Access Compliance Report Public Rights-of-Way (Curb Ramps)

Intersection ID: 4660 Main Street: ELDERBANK_DR Cross Street: TRINITY_RD Location: W

ADA ID: E687C5932A73 Ramp Type: Perp Initial Pass/Fail: Fail Overall Compliance: No Severity Score: 25

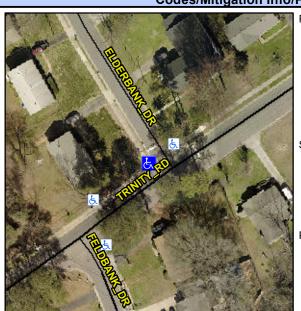
Not Found, R304.2.2, R304.5.3

Field Measurements/Component Compliance					
Comp	liance Description	Data	Comp	liance Description	Data
N/A	Ramp Length (in)	96.5	No	Ramp Slope (%)	8.8
Yes	Ramp Width (in)	77.0	No	Ramp XSlope (%)	5.9
N/A	Flare Type LT	N/A	N/A	Flare Type RT	N/A
N/A	Flare Slope LT (%)	N/A	N/A	Flare Slope RT (%)	N/A
N/A	Flare Traversable LT?	N/A	N/A	Flare Traversable RT?	N/A
N/A	Landing Length (in)	N/A	N/A	DWS Provided?	N/A
N/A	Landing Width (in)	N/A	N/A	DWS Contrast?	N/A
N/A	Landing Slope (%)	N/A	N/A	DWS Length (in)	N/A
N/A	Landing X Slope (%)	N/A	N/A	DWS Full Width?	N/A
N/A	Landing Curb? (Y/N)	N/A	N/A	DWS Offset (in)	N/A
N/A	Shared Landing?	N/A			
N/A	Gutter Ponding?	N/A	N/A	Gutter Slope (%)	N/A
N/A	Gutter Lip Ht (in)	1.0	N/A	Gutter X Slope (%)	N/A
N/A	Painted X Walk1?	No	N/A	Painted X Walk2?	N/A
	X Walk 1 Direction	To E		X Walk 2 Direction	N/A
N/A	X Walk 1 Width (in)	N/A	N/A	X Walk 2 Width (in)	N/A
	X Walk 1 Slope (%)	2.4		X Walk 2 Slope (%)	N/A

Remove & Replace Entire Ramp.
